UNITED STATES PATENT AND TRADEMARK OFFICE

APPLICATION NO.	FILING DATE	FIRST NAMED INVENTOR	ATTORNEY DOCKET NO.	CONFIRMATION NO.
09/960,306	09/24/2001	Donald Richard LaCoy	20272/0688	5354

Office Action Summary

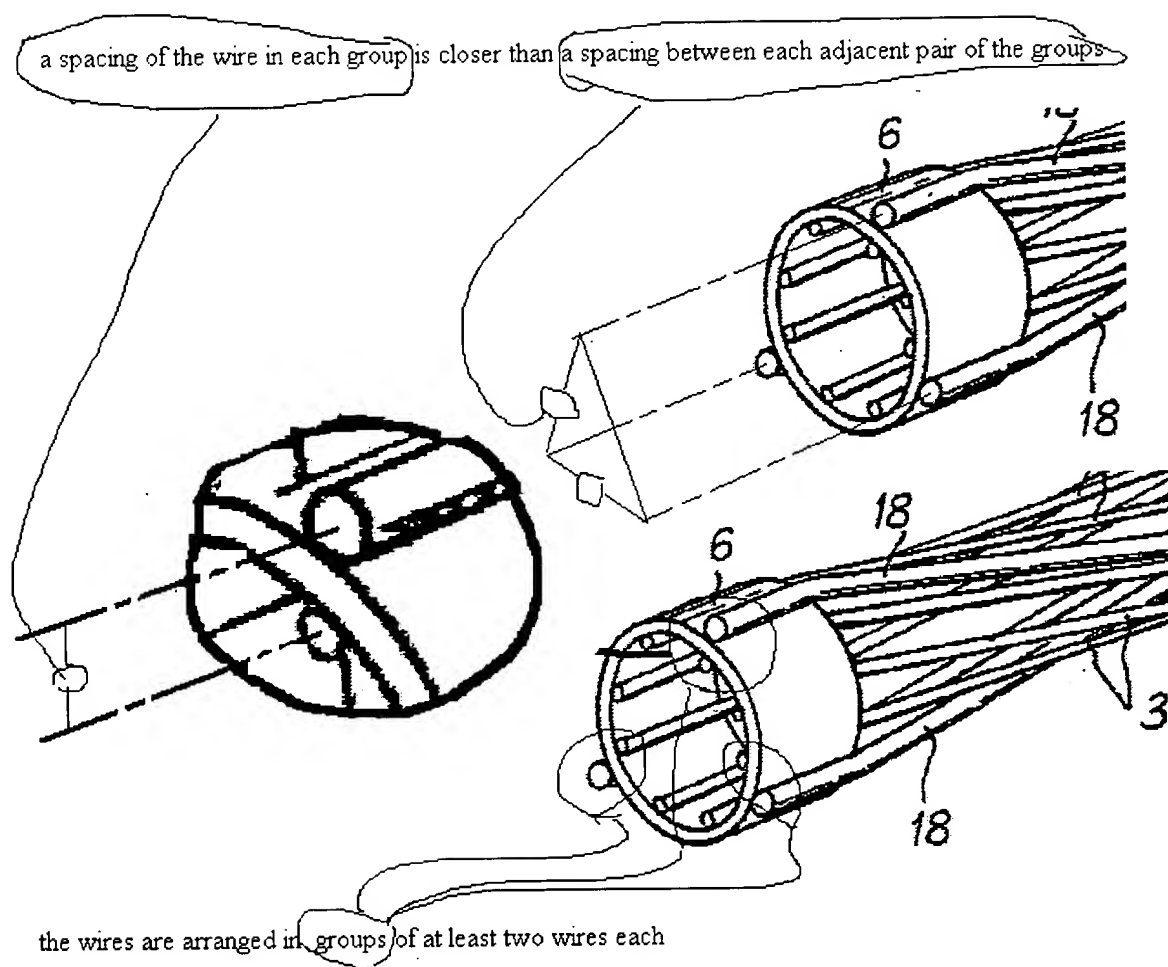
-- In reference to the amended claim language "a spacing between each adjacent pair", the record is not clear if applicant seeks patent protection for a spacing between the circumferential distance or a spacing between a linear distance between the center axis. For purposes of examination, it is assumed that applicant intended to claim the latter (see examiner's figure).

wherein a spacing of the wire in each group is closer than a spacing between each adjacent pair of the groups (see examiner's figure), and

wherein a spacing between adjacent wires in each of the first and second pairs of wires is less than a spacing between each of the three pairs of wires (see examiner's figure), and

-- In reference to claims 3 and 11, the socket includes three groups of two wires each (see examiner's figure) .
